## INDEX TECHNICAL SERVICE BULLETIN

**IMx® (60)**

SUBJECT:  
**WorldWide Upgrade of IMx® System Software to revision 6.0**

TSB#: **60-040A**

**Figure 1**  
**FPIA Optics assembly**  
**showing VDE configured**  
**PMT high voltage wire shielding**

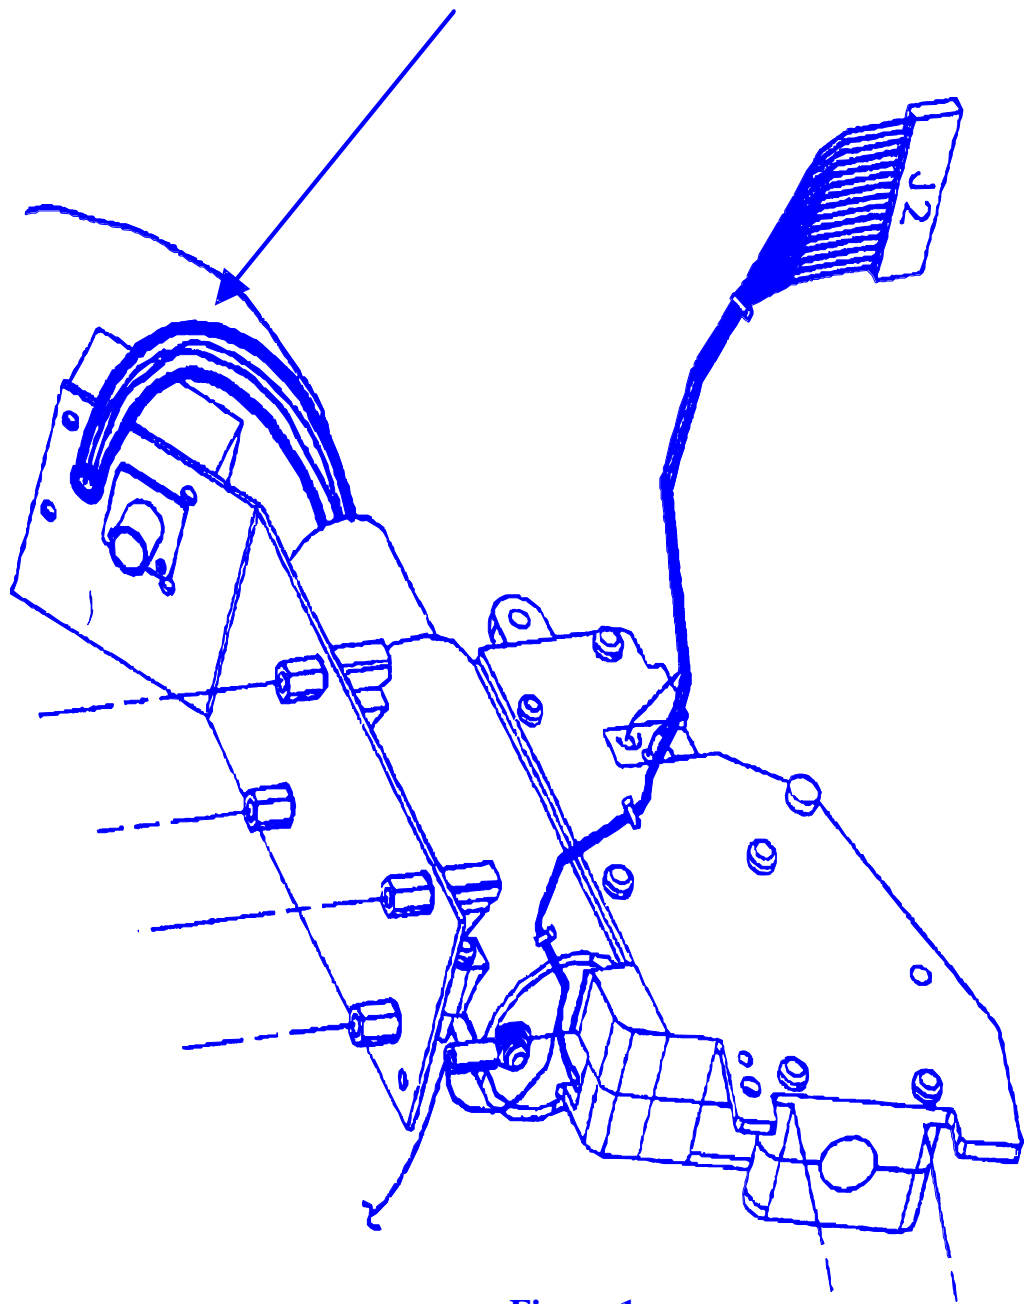
This TSB is to inform the field that since releasing VDE Certified IMx® analyzers, refurbished FPIA Optics assemblies ( 3-31008-02 ) have not been meeting VDE Certification. All new build FPIA Optics meet VDE Certification. The PMT connector on the refurbished optics has not had heat shrink tubing or clear tubing placed over the violet and black high voltage wires. This does not meet VDE standards. See Figure 1 for reference.

Verify that the PMT connector wires ( violet and black ) have a clear tubing or black heat shrink tubing covering them ( See Figure 1 for reference ). If they do not, perform the following:

**Clear tubing or black heatshrink must enclose the violet and black high voltage wires to conform to VDE requirements.**

European sites - Replace the FPIA Optics assembly with one that has the clear tubing or heat shrink applied to the pmt wiring. Attach a returned goods tag to the optics and fill it out completely. In the remarks section put: "Replaced per TSB 60-039 non-VDE FPIA Optics"

**Figure 1**  
**VDE Certified Board showing**  
**proper location**  
**of artwork label.**  
**( Solder side of PCB )**

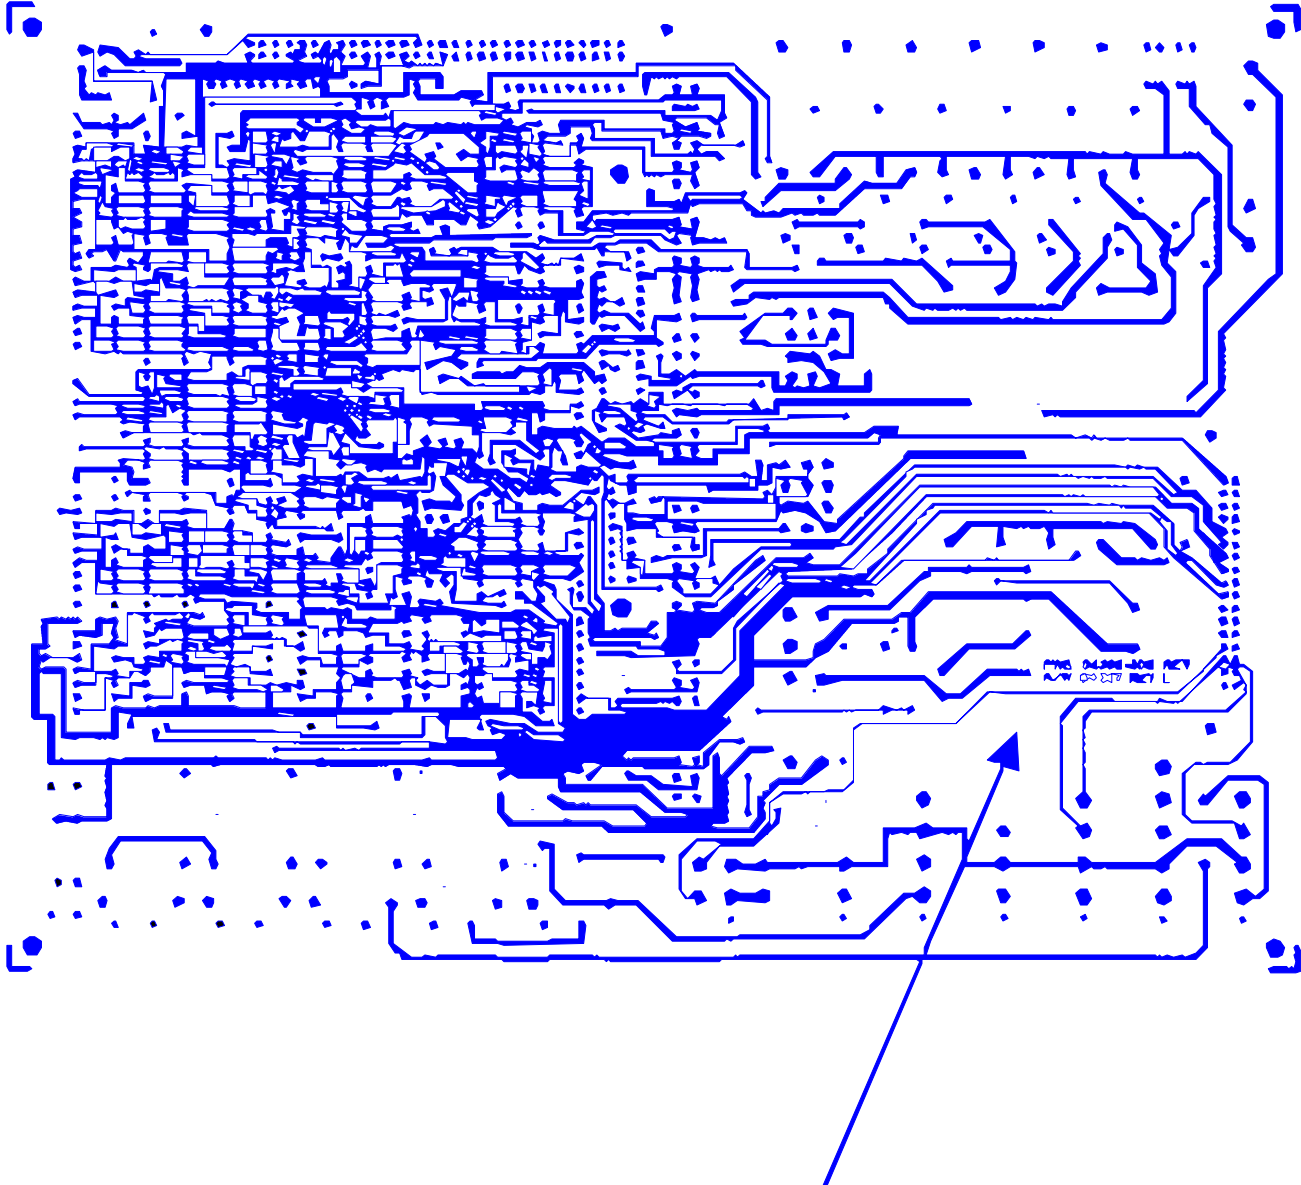
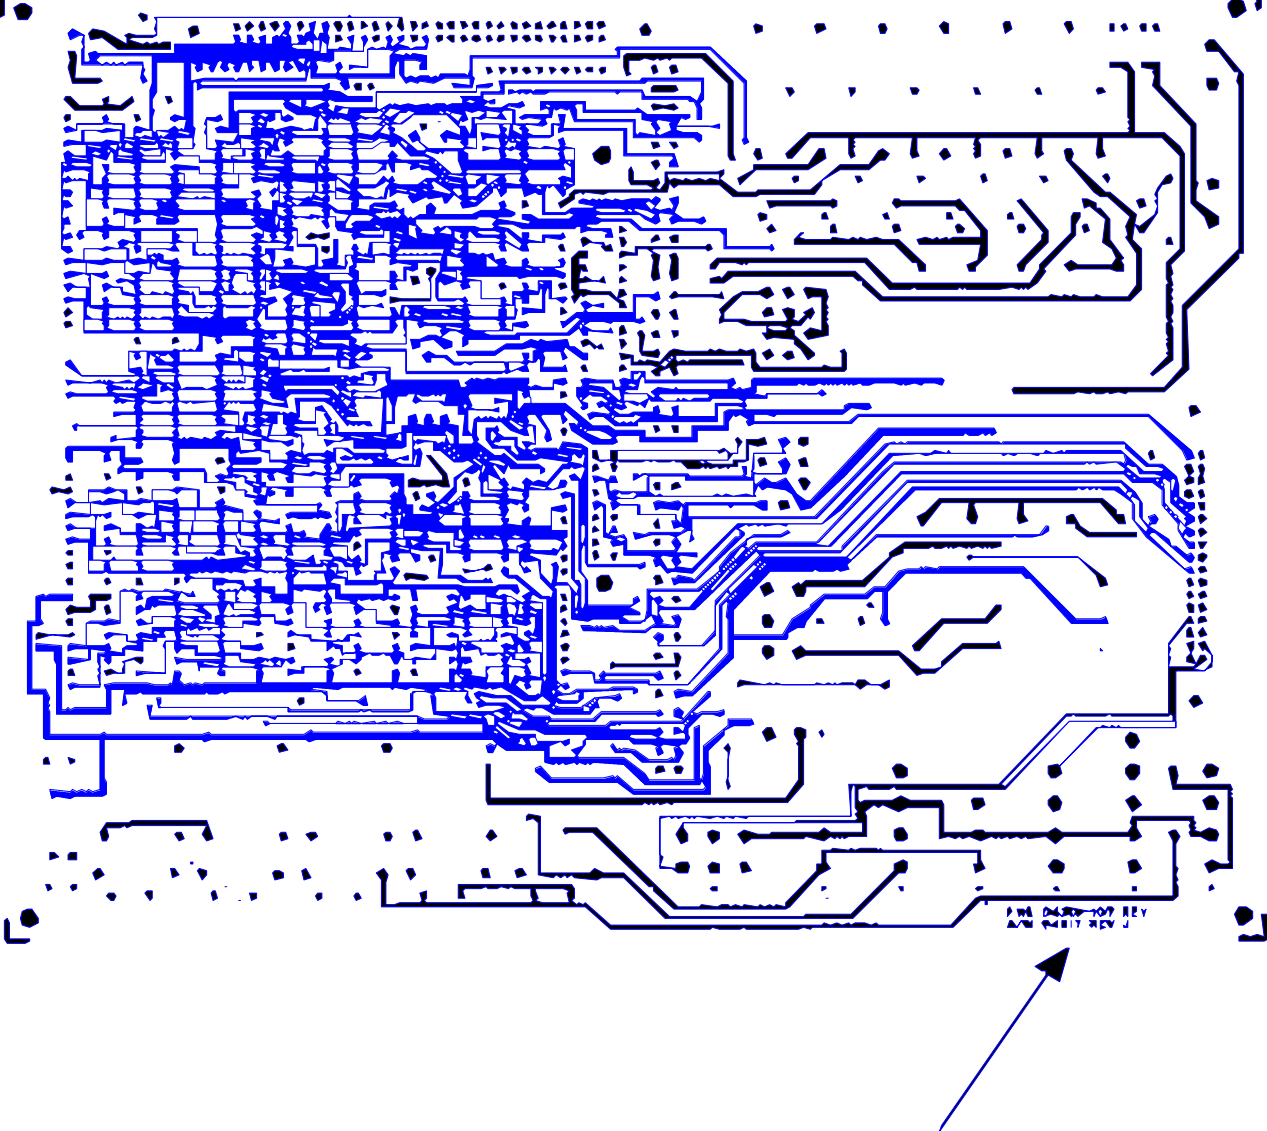
***A diagram, Figure 1, shows the artwork placement of the VDE certified PCB's. Artwork in any other location means that the PCB is not VDE certified. Figure 2 shows a non-VDE PCB artwork placement. Both figures reference the Solder side of the PCB.***

Look at the solder side of the Motor Driver PCB and locate the artwork printing, referencing Figure 1 for the correct location and Figure 2 for non-VDE configuration.

If the artwork is in the same location as Figure 1, you can reinstall that Motor Driver PCB.

If the artwork is in the same location as Figure 2, replace the Motor Driver PCB with the one from your parts kit. If you installed a 3-04915-01 into the instrument, you will need to remove the VDE sticker from the rear of the Enclosure (see illustration below). If you installed a 3-04915-02 into the instrument, the VDE sticker can remain on the Enclosure.

Figure 1

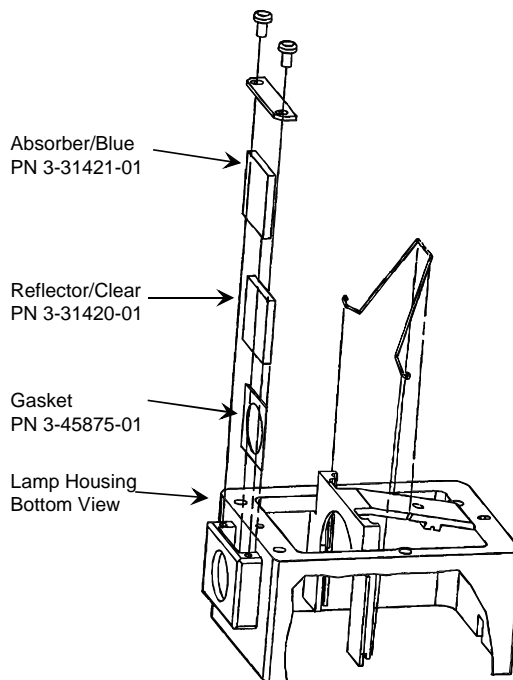
6. Clean the two lenses with lens paper.
7. Reinstall the two lenses and one or two gaskets (3-45875-01) as required to create an airtight fit between the body of the Lamp Housing and the Heat Reflector Lens. (See Figure 1.) If the lenses cannot be reinstalled with at least one gasket in place because it is too tight, try other gasket and lens combinations using service kit parts. If still unable to find a set that fits, order and replace the entire Lamp Housing Assembly, 3-31054-01, which will have the gasket and lenses already installed.

*Figure 1*  
*VDE Certification Label*

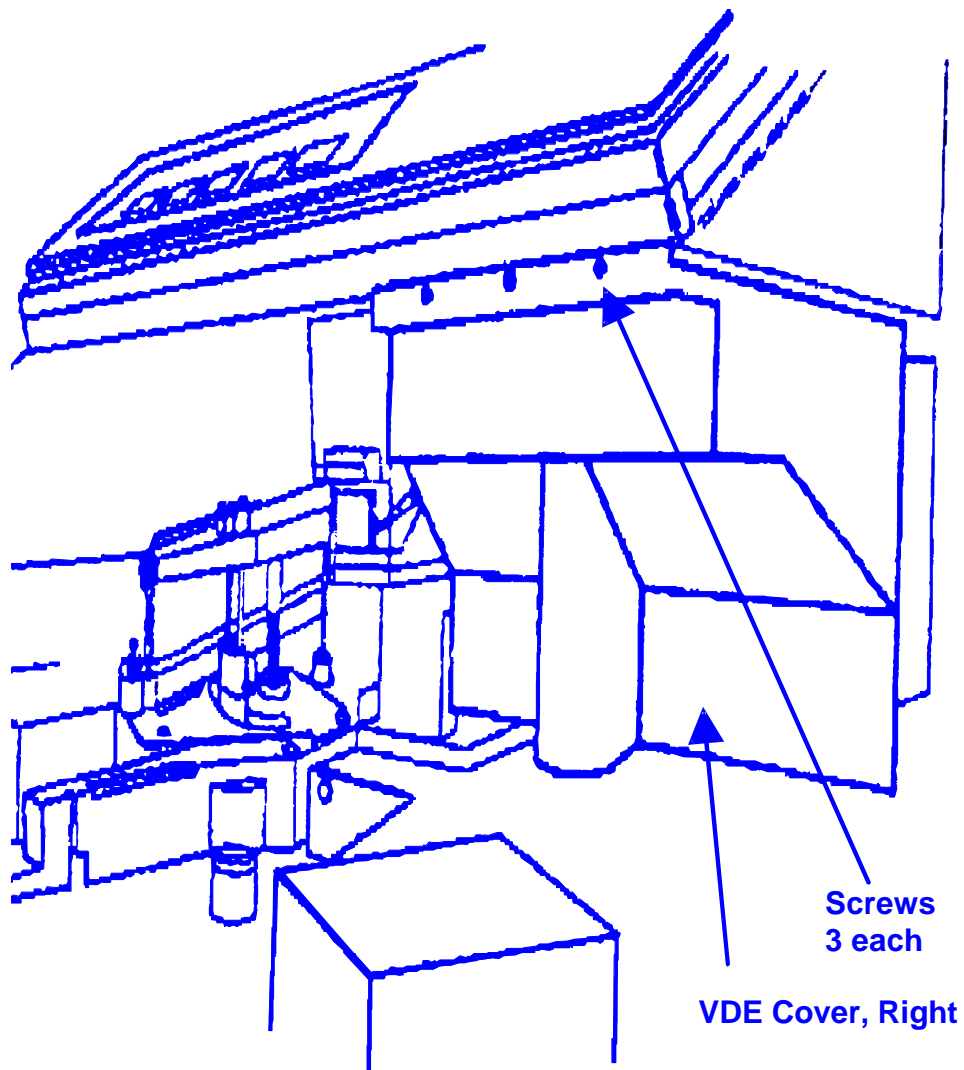
All new build IMx's above S/N 20706 will be VDE certified. This entails changes required by VDE as listed in Table 1. A brief description of changes is included. A VDE label will be affixed to the back of the IMx denoting certification. See Figure 1 for label.

**If you put non-VDE parts in a VDE Certified IMx, you will need to remove the VDE sticker on the back of the IMx. At this point the IMx is no longer VDE Certified and can not be upgraded again. This is because VDE requires that their sticker be installed only at the manufacturing facility that it has approved.**

### **Figure 3**

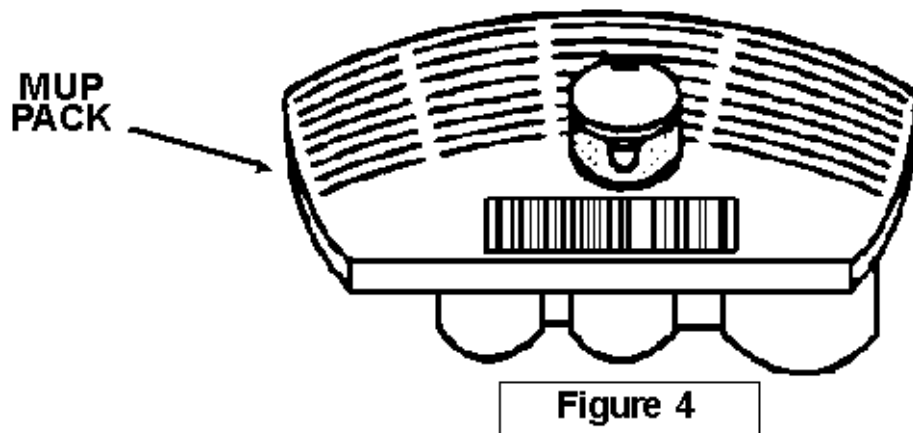
A new step, specific to SELECT, has been added to the Boom Calibration procedure. The additional step determines the horizontal positioning for the probe/electrode assembly for all reagent packs located in the SELECT carousel. This additional location, CRSL\_RGNT, is calibrated by centering the probe over the cross target at the center of the buffer pack cap in location A in the SELECT carousel. The vertical limit is set by the LLS portion of Boom Cal.

Adjust the boom and carousel as necessary, using Figure 3 as guide.

Figure 1

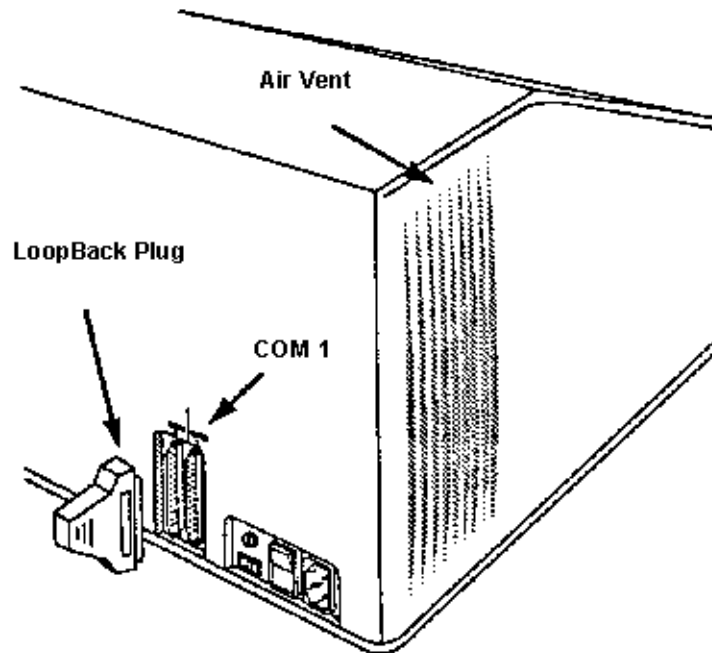
When Revision 5.0 Software is released, the customer will be using a Bar Code Scanner to aid in patient sample/reagent identification. The Bar Code Scanner will be plugged into the COM1 port (the port nearest the ON/OFF switch) via a 25 pin connector. It has been found that the Com1/Com2 ports at the rear of the IMx may not align properly, which will prevent the bar code scanner from being attached. This TSB is being issued to correct this problem.

Locate the Com1 and Com2 ports at the rear of the IMx. See Figure 1. Using the loopback plug that comes in your Tool Kit, connect the plug into each port. Insure that the plug is centered Top-to-Bottom on both connectors. Since the loopback plug is smaller than the Bar Code Scanner connector, this procedure requires centering of the loopback plug.

Figure 2

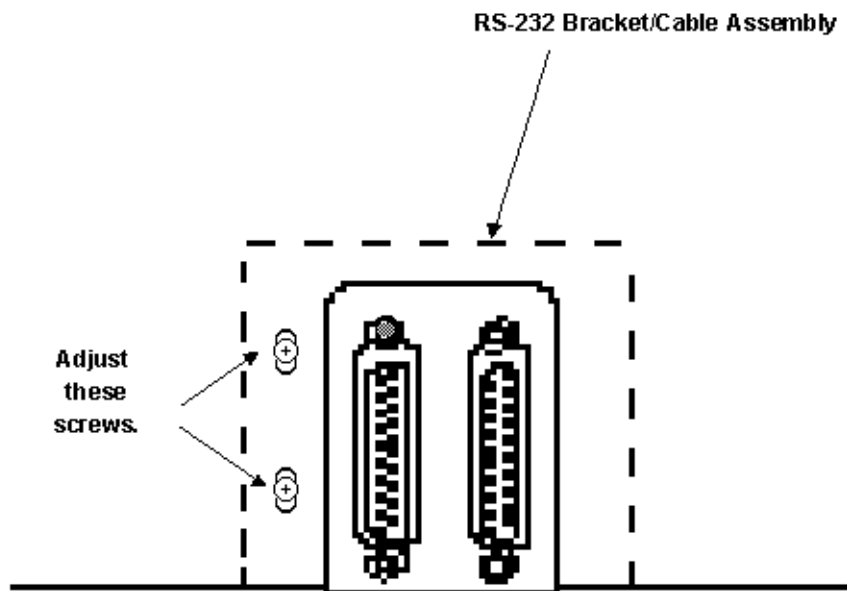
3. Locate the two screws mounting the RS-232 bracket to the cardcage assembly. See Figure 2. Loosen the two screws and adjust the bracket as noted in step 1 above.

Figure 2  
ASIC CPU Board Layout

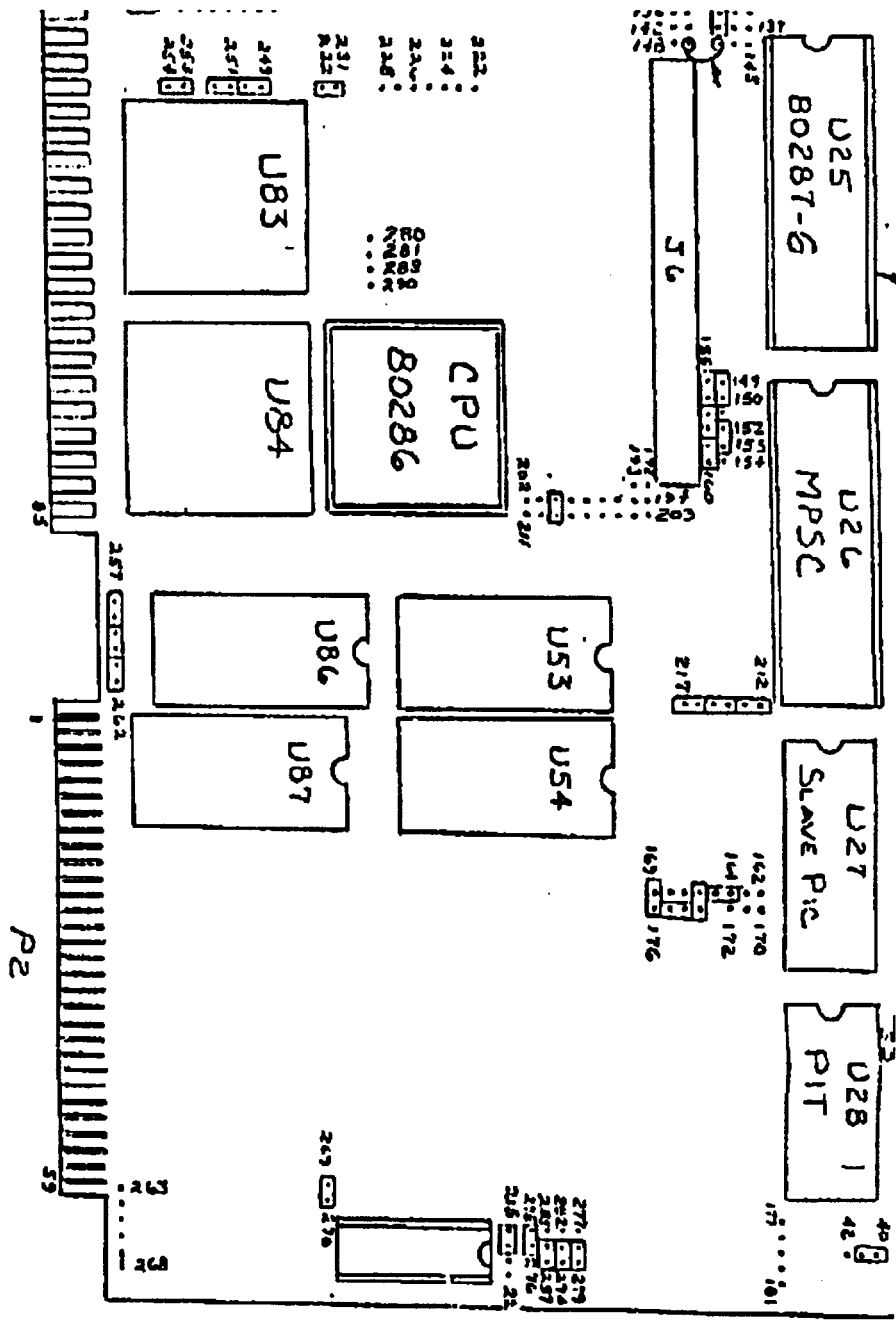
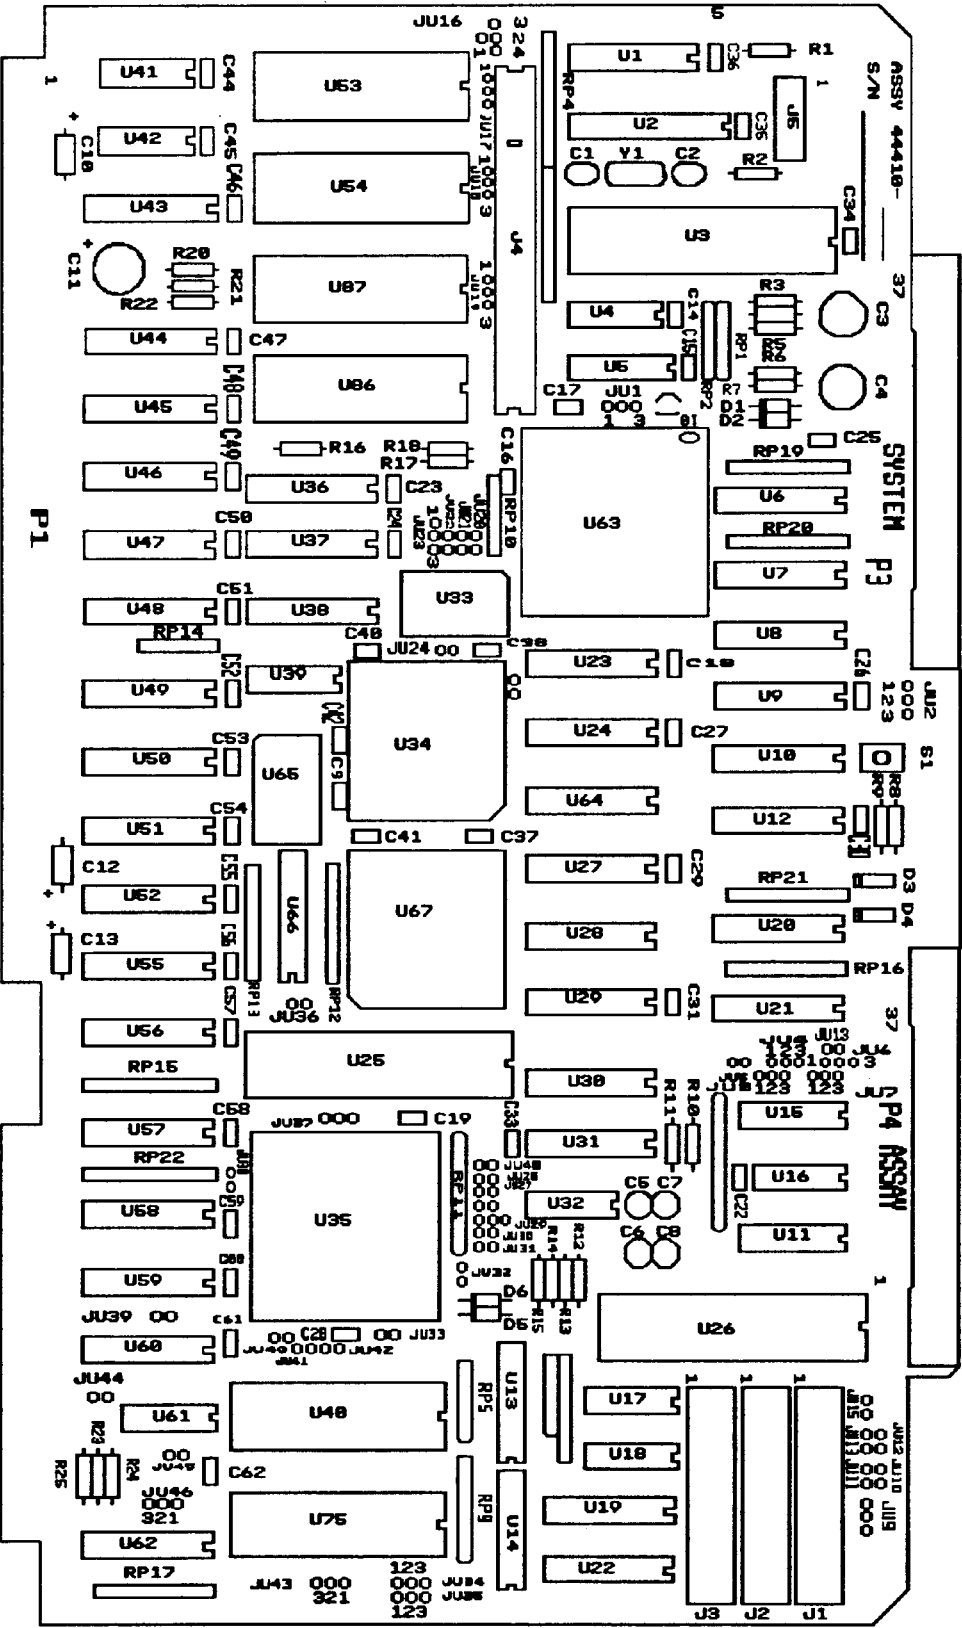
Before installing the new ASIC CPU board, remove all four NOVRAMs (U53,U54, U86, U87). Refer to Figure 2 for location. Set the NOVRAMs aside.

Next, remove NOVRAM U53 from the Intel CPU board and install it in the U53 socket on the ASIC CPU board. Refer to Figure 1 for location of NOVRAMs on the Intel CPU board. Note Novram orientation in Figure 4.
